Model: Trimmer Unit 5020	Date: 04-Nov-2010	No.: RD455002
--------------------------	-------------------	---------------

Model: Trimmer Unit TR5020 (D455)		Date: 18-Nov-10	No.: RD455003
Subject: 11 screws replaced with generic screws		Prepared by: T. Komori	
From: PP Service Planning Department 1G			
Classification:	<input type="checkbox"/> Troubleshooting <input checked="" type="checkbox"/> Part information <input type="checkbox"/> Action required <input type="checkbox"/> Mechanical <input type="checkbox"/> Electrical <input type="checkbox"/> Service manual revision <input type="checkbox"/> Paper path <input type="checkbox"/> Transmit/receive <input type="checkbox"/> Retrofit information <input type="checkbox"/> Product Safety <input type="checkbox"/> Other () <input type="checkbox"/> Tier 2

Model: Trimmer Unit TR5020 (D455)		Date: 22-Sept-11	No.: RD455005
Subject: Adjustment of the trim volume		Prepared by: T. Komori	
From: PP Service Planning Department 1G			
Classification:	<input type="checkbox"/> Troubleshooting <input type="checkbox"/> Mechanical <input type="checkbox"/> Paper path <input type="checkbox"/> Product Safety	<input checked="" type="checkbox"/> Part information

14.Tray Section 1 (D455)

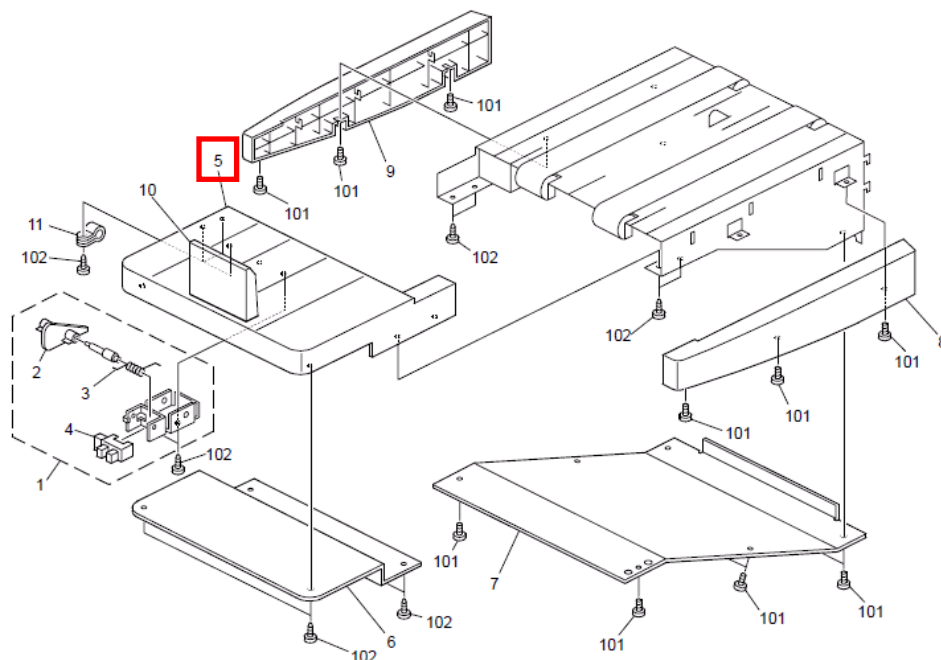
Change: New p/n D4556137 has been registered for the tray.

Reason: p/n D4556131 had been falsely deleted from the parts registration system.

Old Part Number	New Part Number	Description	Q'ty	I/C	Page	Index
D4556131		FRAME:TRAY:YZ2-08408123	1→0	O/O	28	5
	▶D4556137	FRAME:TRAY:YZ2-08408128	0→1	O/O	28	5

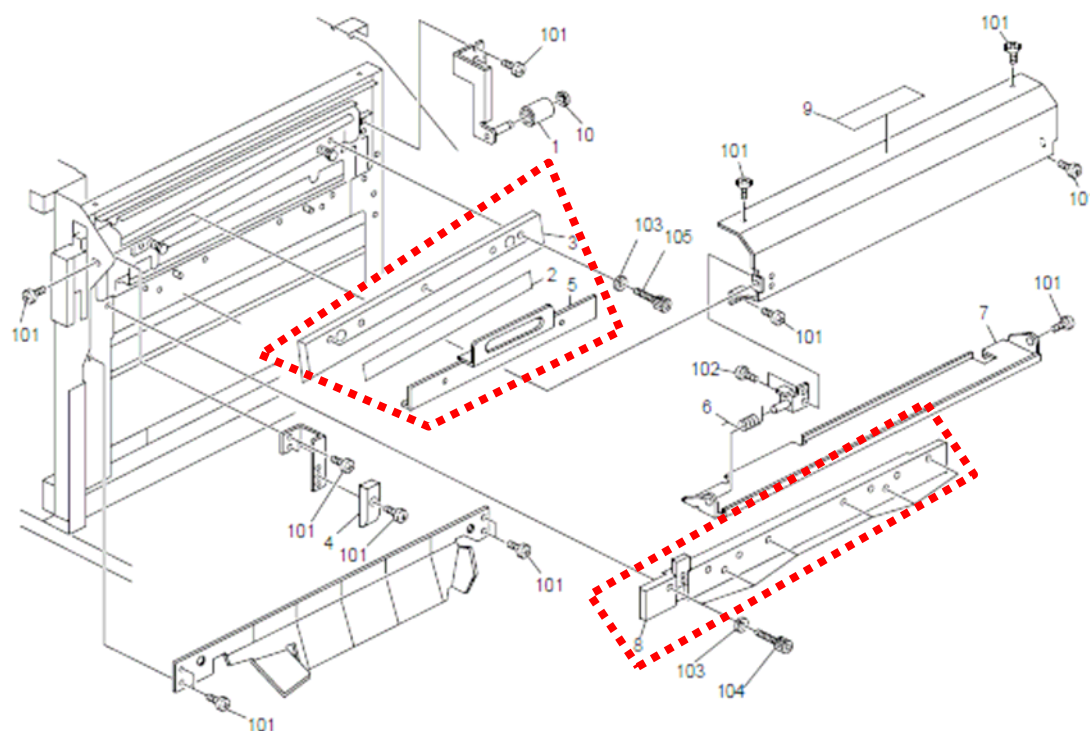
Change: Parts were added

Reason: To allow easier purchase order of the cutter assembly

New Part Number	Description	Q'ty	Page	Index	Note
D4551381	CUTTER:YZ3-08400095:ASS'Y	1	23	11	Add
D4551382	DRIVER	1	23	12	Add

* "DRIVER" is a hexagon wrench which should be used when replacing the cutter assembly.

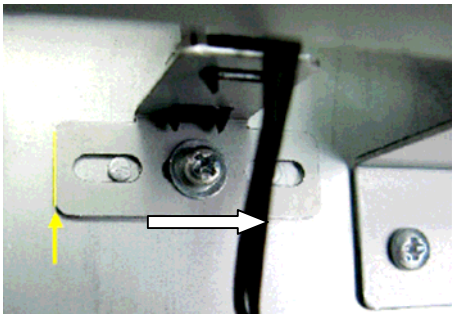
- Remove the covers as shown in the diagram.

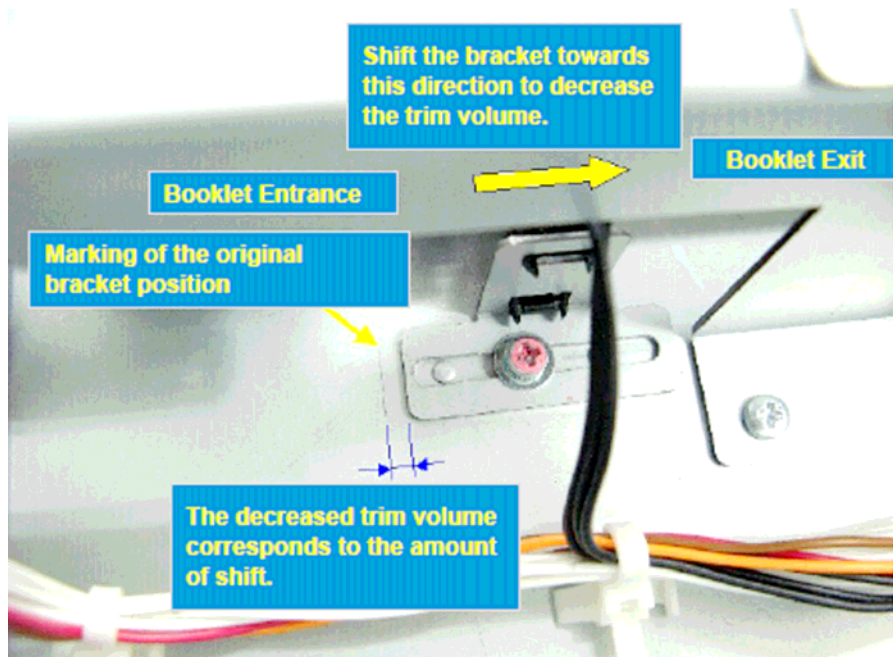
3. Identify the sensor.

4. Move the bracket in the direction of the arrow (decrease in trim volume).
Check the trim volume.

DO NOT shift the sensor bracket in the opposite direction (increase in trim volume) as this may cause damage to the machine due to interference with the registration unit.

5. Reassemble the unit when the desired volume is obtained. If not satisfy the customer's demand, please go method #2.

13.Paper Exit Section 2 (D455)

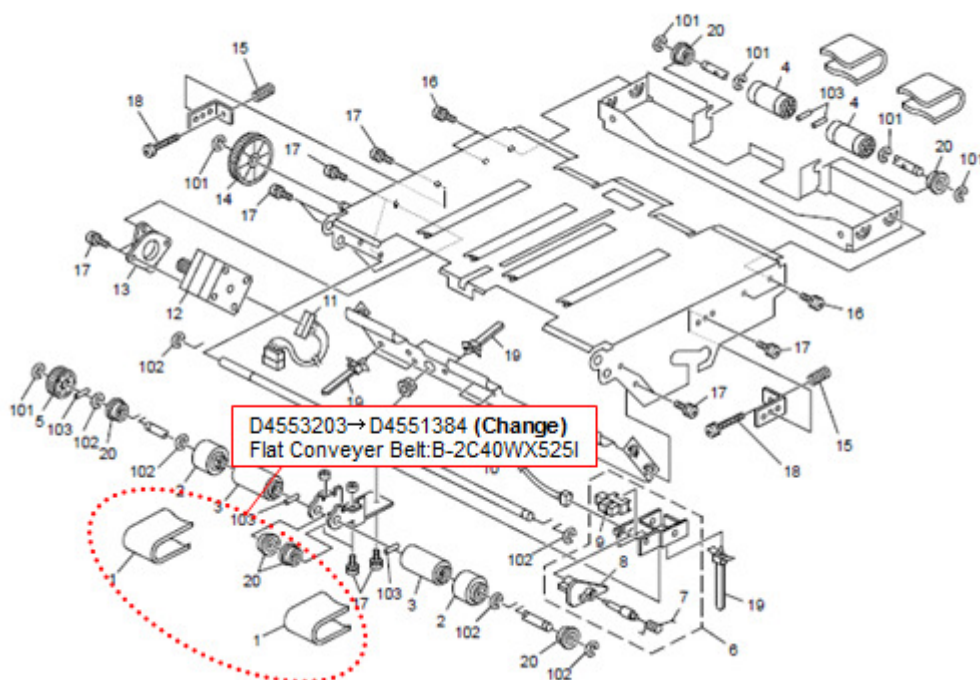
Change: Color of the Flat Conveyer Belt was changed from Black to White.

Reason: To prevent image contamination when correcting skew

Old Part Number	New Part Number	Description	Q'ty	Int	Page	Index	Note
D4553203	D4551384	Flat Conveyer Belt:B-2C40WX525I	2	X/O	26	1

8.Jogger Section 3 (D455)

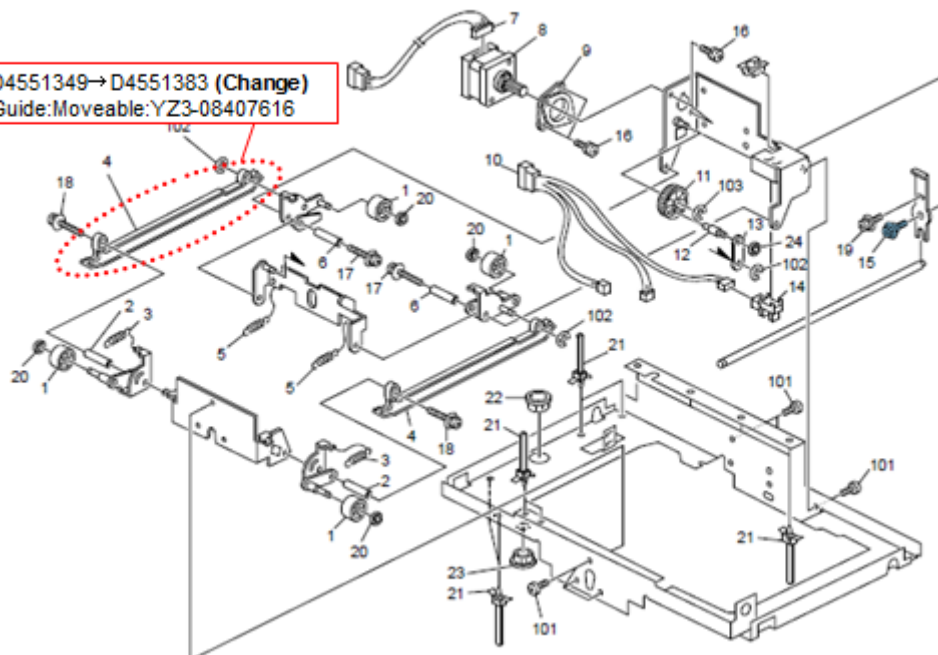
a) Modification to secure higher accuracy in booklet position for cutting

D4551349→D4551383 (Change)
Guide:Moveable:YZ3-08407616

Old Part Number	New Part Number	Description	Q'ty	Int	Page	Index	Note
D4551349	D4551383	Guide:Moveable:YZ3-08407616	2	X/O	16	4

14.Tray Section 1 (D455)

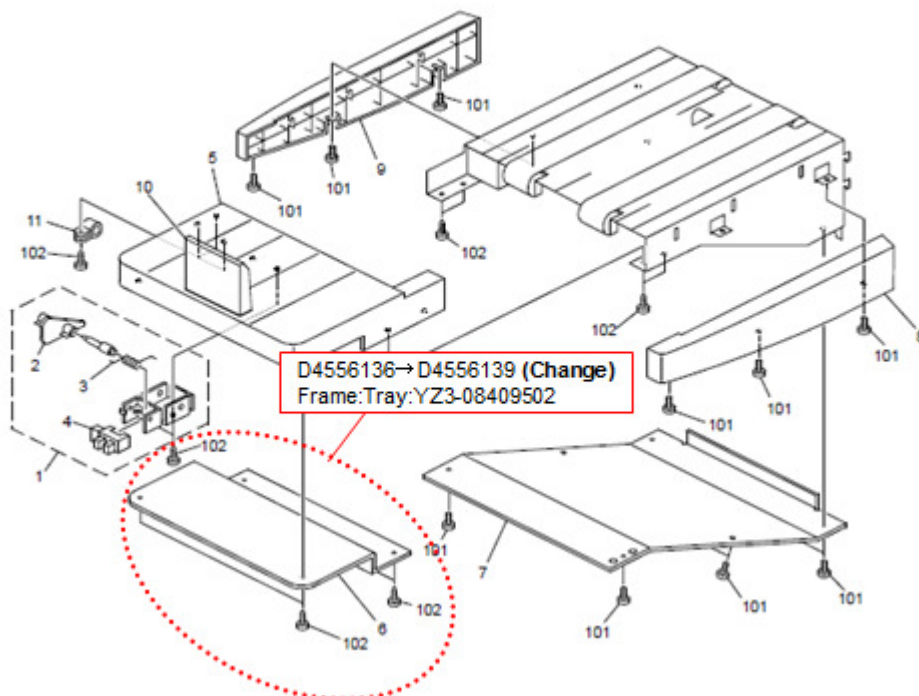
b) Modification to correspond with the limitless feeding switch

D4556136→D4556139 (Change)
Frame:Tray:YZ3-08409502

Old Part Number	New Part Number	Description	Q'ty	Int	Page	Index	Note
D4556136	D4556139	Frame:Tray:YZ3-08409502	1	X/O	29	6	
-	D4553225	PAN HEAD SCREW:M2X10(P3)	2		29	12	
-	D4556140	BRACKET:MICRO SWITCH:YZ4-09069601	1		29	13

If the Tray Frame is to be replaced for limitless feeding, the 2 parts shown below will also be required in addition to the 3 parts shown in the above table.

- **D4553121 Wire Binder:RSG-100_V0 (Q'ty: 1)**
- **D4553133 Binding Self Tapping Screw:4x8 (Q'ty: 2)**
